**FLORIDA ROCK INDUSTRIES INC**

RE: Correction to Draft Permit No. 0010087-031-AC (PSD-FL-350A)  
Florida Rock Industries, Inc.—Thompson S. Baker Cement Plant  
Facility ID 0010087

**MECHANICAL PROCESS FLOW SHEET**  
**CLINKER SILOS AND ADDITIVES; LINE 1**  
**2300 STPD CLINKER**

Sheet No: **D**      Sheet of: **110.59.51-0007**      Rev: **F**

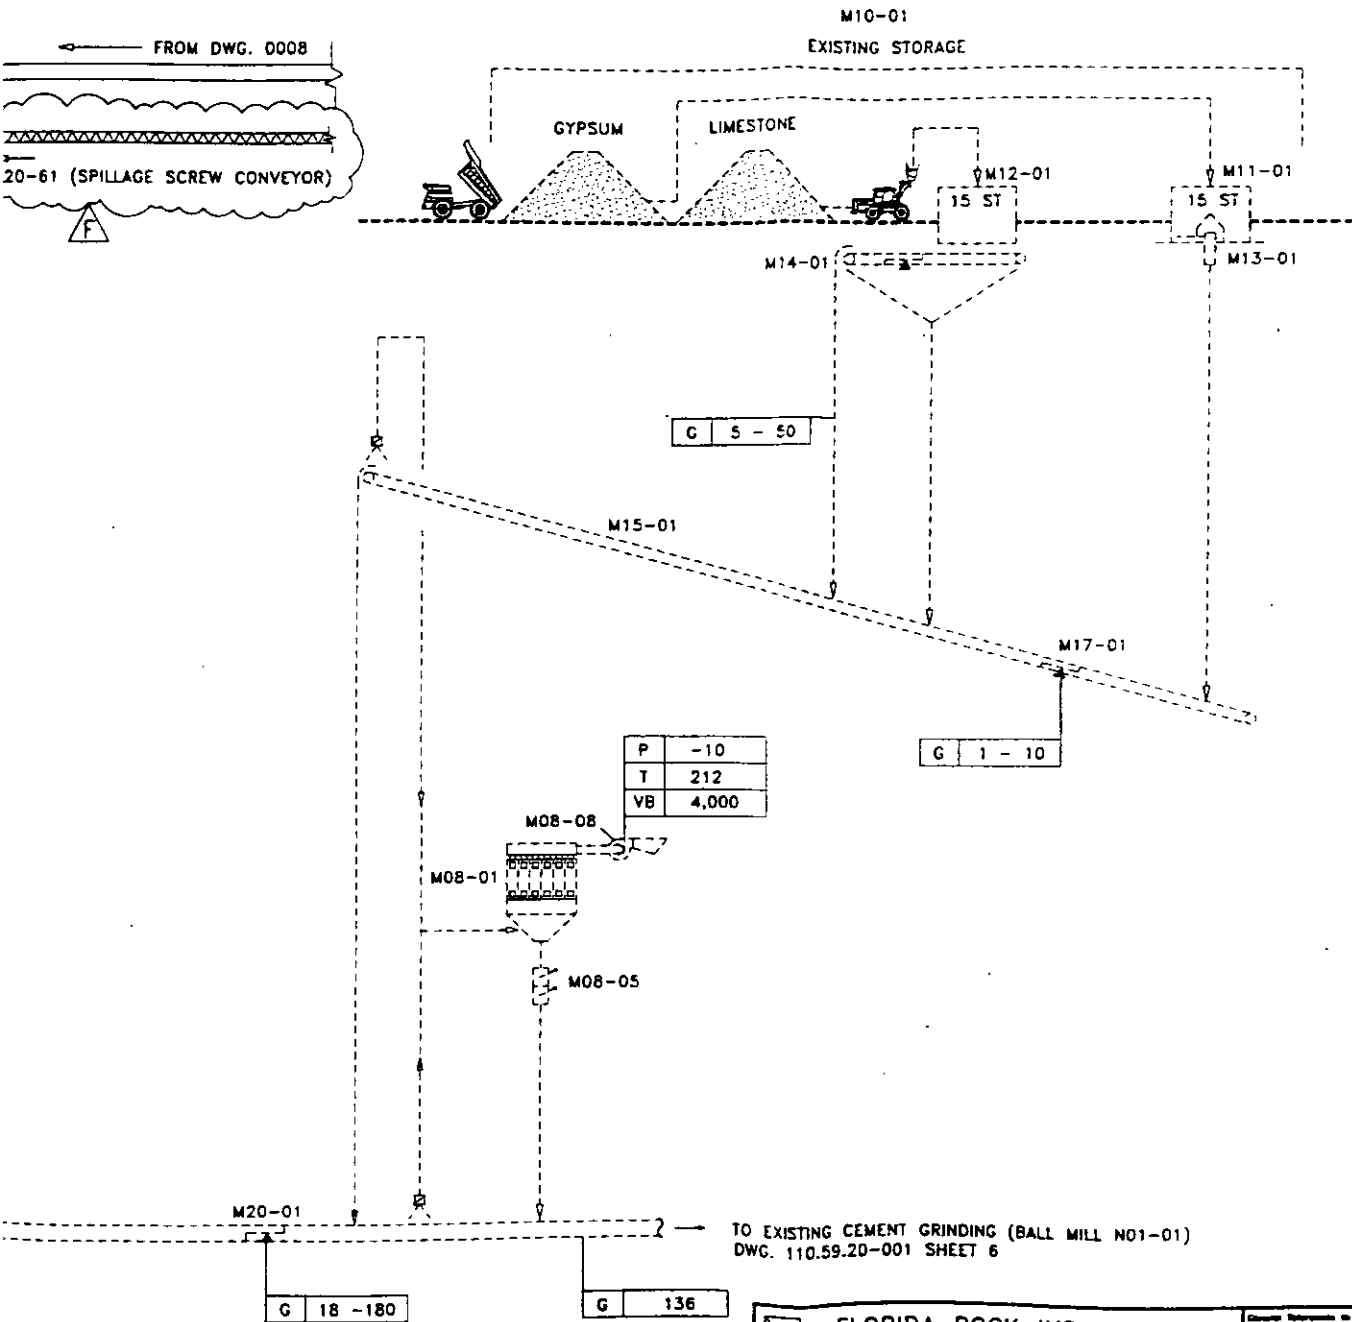
The second correction is to the description of emission point 2L15 under condition 16. Specifically, we request that the description be made to read "Clinker Transport (2L20, *silo L07-02*, and 2L09)". Drawing no. 110.59.51-0007, which you have on file as part of our earlier applications, is highlighted to show this relationship.
